Final Draft August 22 2021 Summary of Wiehle Study Group (006)	2
Appendix 1 - Proffers pages 1,17-33	9
Appendix 2 - FCDOT Wiehle Ave Study Group Presentation 9.17.2020	27
FCDOT Wiehle Ave Study Group Presentation 10.15.2020	71
Appendix 3-Tammi Petrine suggestions and maps	122
Appendix 4 -Rob Walkers cross walk concept	129
Appendix 5 - Approved CDP-FDP Sheet C-7	130

Memorandum

Re: Results of the Study Group Findings

Sunrise Valley ‘T’ Intersection Details:

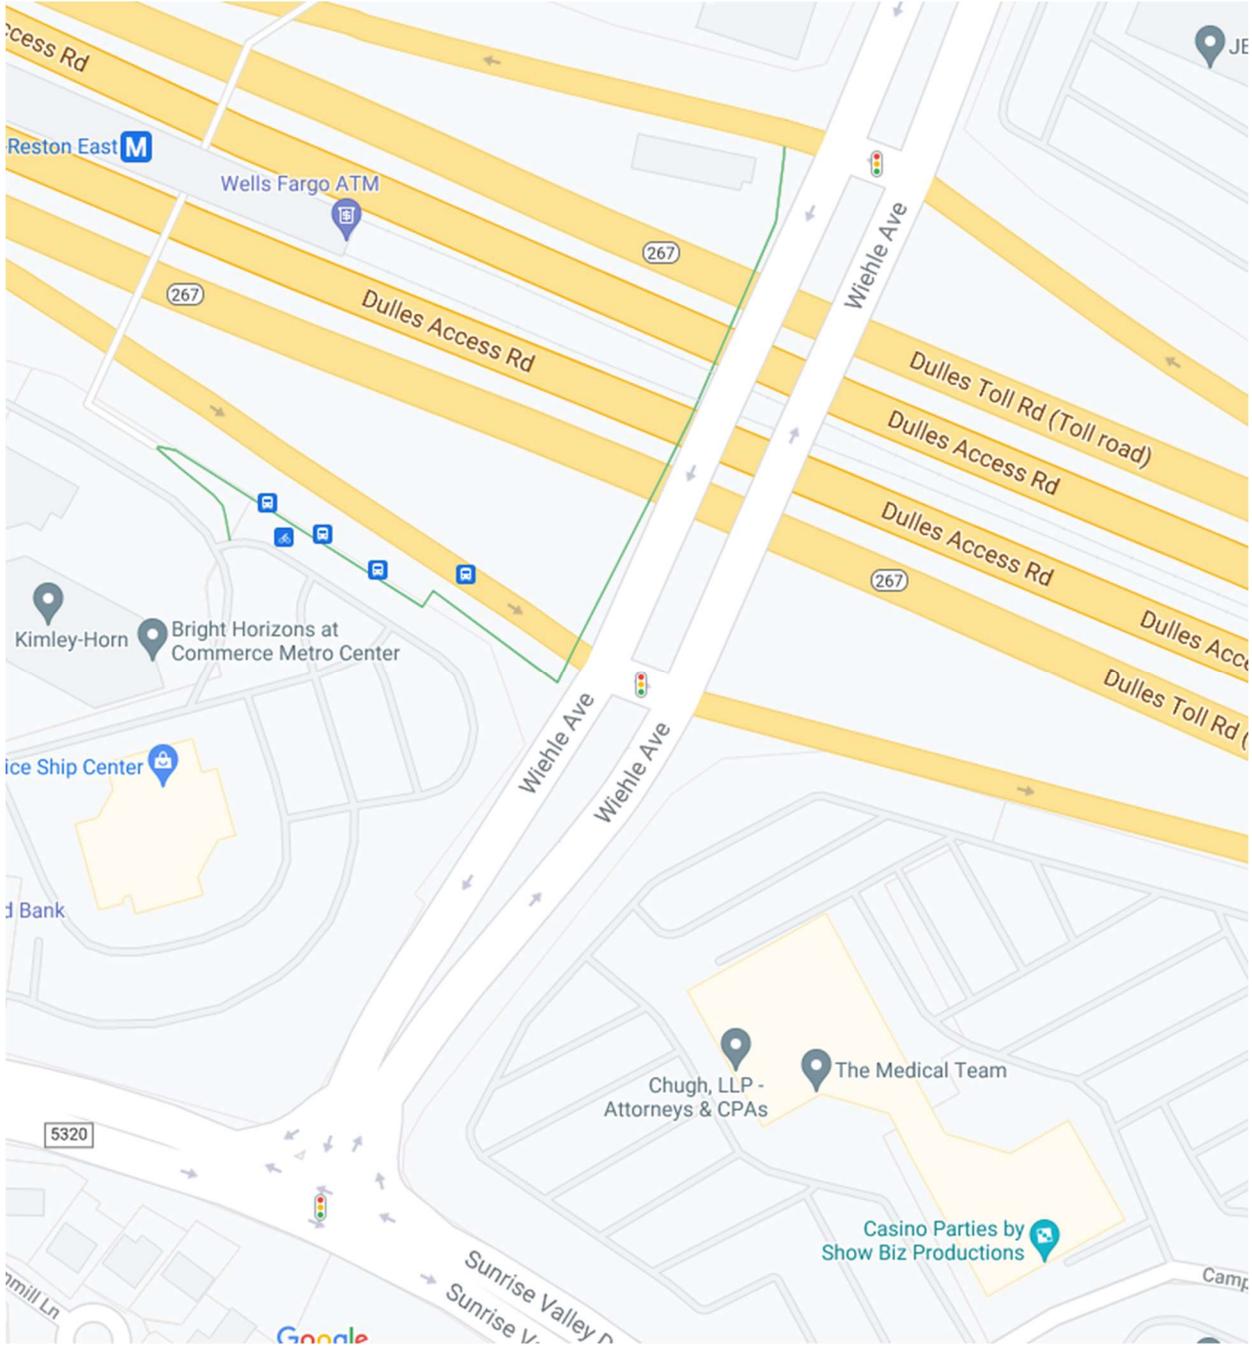
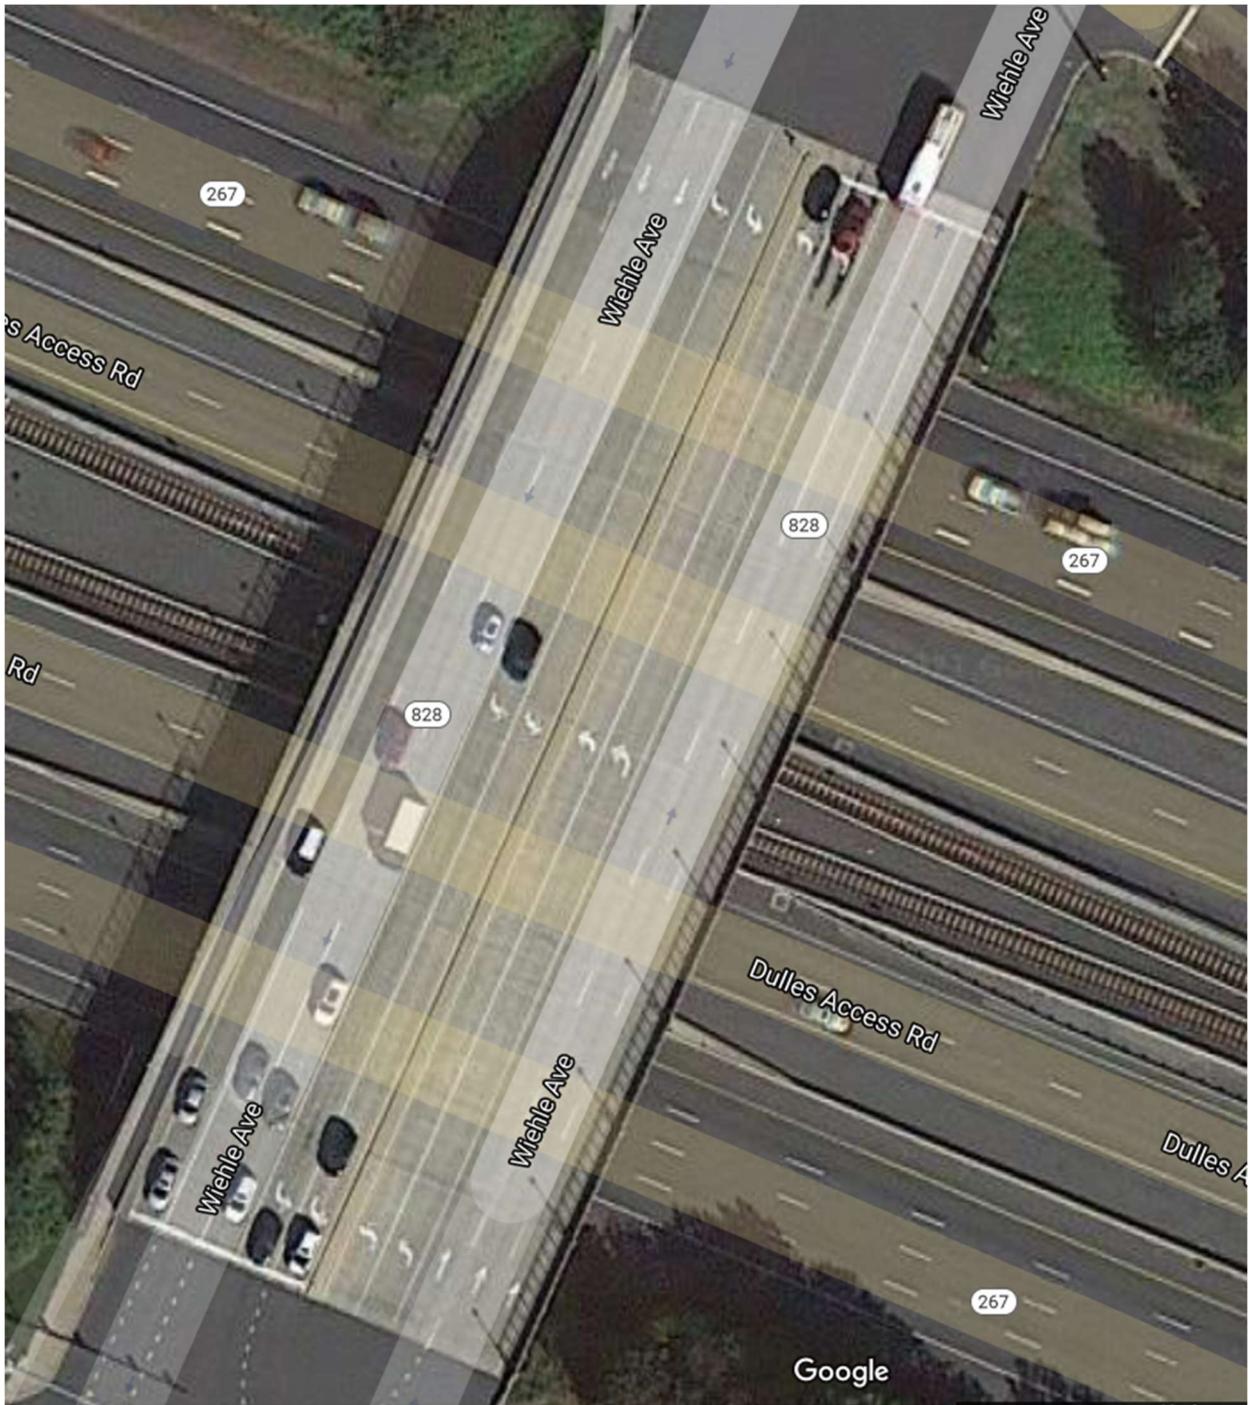
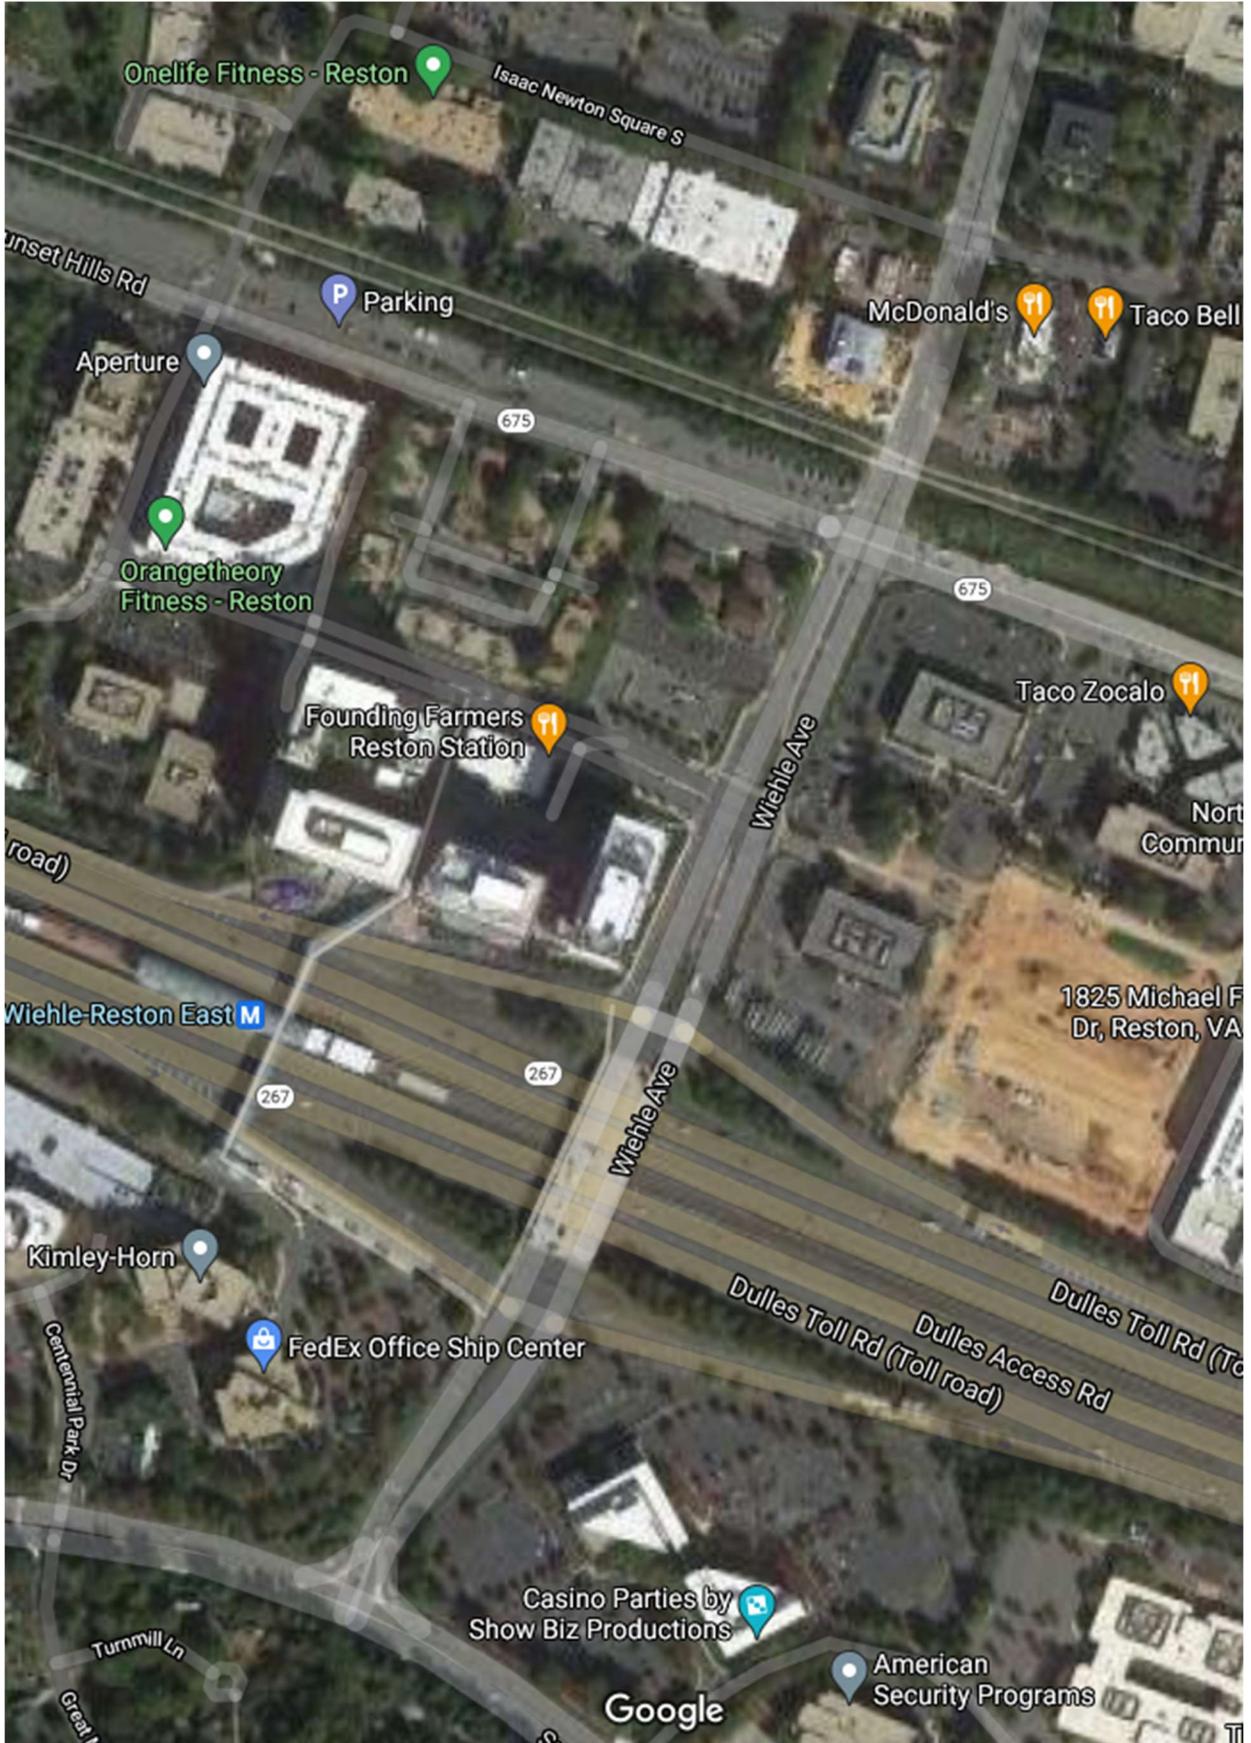
5. Reduce vehicular curb turn radii to slow down traffic.
6. For south-bound Wiehle traffic, eliminate continuous right turn option and emphasize **FULL STOP** for vehicular/cycle traffic turning west-bound onto Sunrise Valley.

7. Consider blinking red during late night/early morning hours of light multi-modal usage at this intersection.
8. **Provide N/S pedestrian crossing ONLY at west side of Sunrise Valley T due to huge demand on Sunrise of vehicles to access Wiehle Bridge and complex stoplight timing challenges.**

- a. Need to prevent west-bound backups/stack-backs on Sunrise Valley that prohibit southside neighborhoods from accessing Sunrise Valley Drive during rush hours despite provision of two traffic lights allowing same.

- b. Reconsider adding east side pedestrian crossing with accompanying north-bound sidewalk to this T intersection **ONLY** when East side pedestrian and cycle track bridge across DTR is provided.

9. Provide simple E/W pedestrian/cycle track crosswalk at junction of Wiehle/Sunrise governed by stop light with no porkchops. Continue color codes as appropriate to promote predictability in this crosswalk.
10. Designated colors for peds/cycle lanes continue onto Sunrise so that users stay in appropriate lanes for safety/predictability.

Comprehensive multi-modal connectivity study AND implementation is imperative ASAP.
